DOMINION VIRGINIA POWER
NORTH ANNA UNIT 3 COMBINED LICENSE APPLICATION
SRP 3.3.1 AND 3.5.1.6: RESPONSE TO RAI LETTER 51

RAI 5138 Question 03.03.01-1

RAI 5214 Question 03.05.01.06-1

Figure 1: Location of Airports and Airways

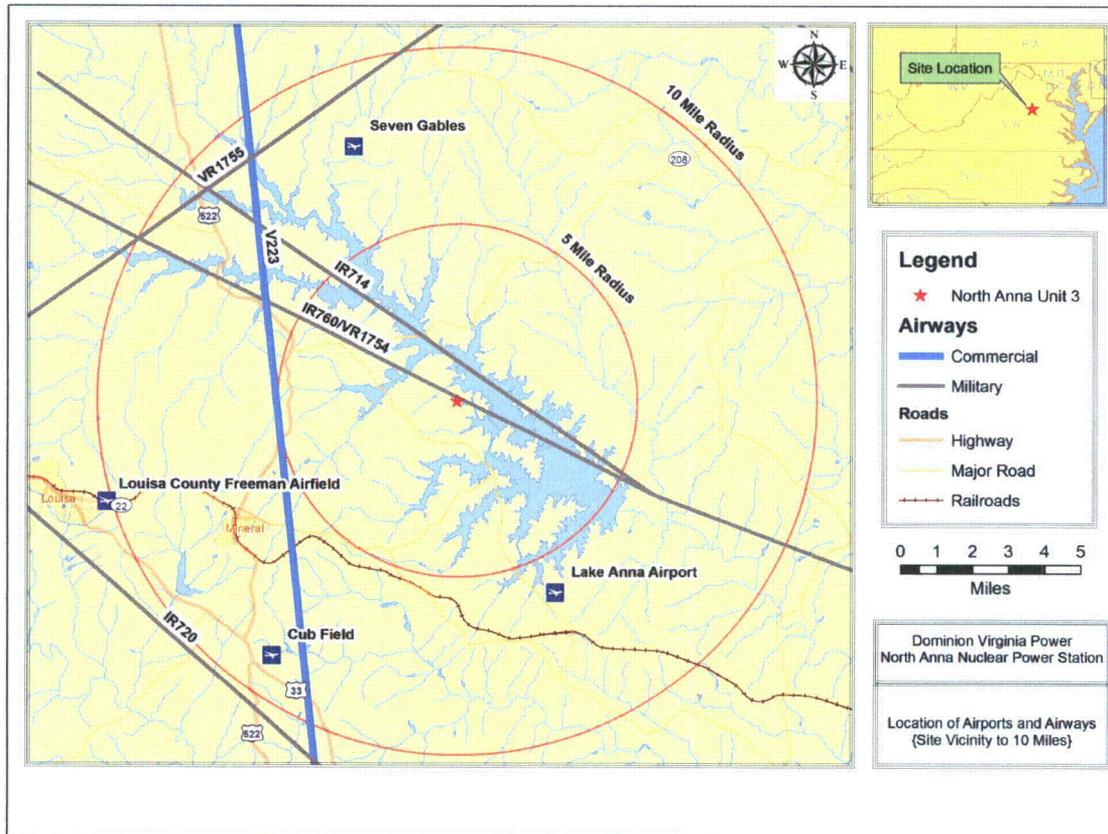
RG 1.206 provides guidance regarding the information that NRC needs to have reasonable assurance that potential hazards in the site vicinity are identified and evaluated, in accordance with the siting criteria in 10 CFR 100.20 and 10 CFR 100.21. In the North Anna Unit 3 COL FSAR, Section 3.5.1.6, the applicant reported aircraft impact probabilities from operations along civil airway V-223 and military routes IR714, IR760/VR1754, and VR1755. However, the applicant did not describe the effective area of the plant used in its calculation. Though the total probability calculated by the staff is on the order of 10^{-6} per year, the applicant concluded that the total probability is approximately 10^{-7} per year. The staff requests that the applicant explain its aircraft impact probability calculation in sufficient detail to allow an independent review, including a description of the effective area information assumed in its calculations.

The arrangement of each airway and location of Unit 3 are shown in Figure 1 below. Distances from the site to each airway were calculated and applied to this analysis. One commercial airway, V223, passes by the site. The width of a commercial airway is 8 nautical miles or 4 nautical miles on each side of the centerline. One nautical mile is equivalent to 1.15 statute miles; therefore, the corridors are 4.60 statute miles wide on each side of the centerline. Four military routes, IR714, IR 760/VR1754, IR720 and VR1755 pass by the site. The width of a military training route is 10 nautical miles (11.5 statute miles) or 5 nautical miles (5.75 statute miles) on each side of the centerline.
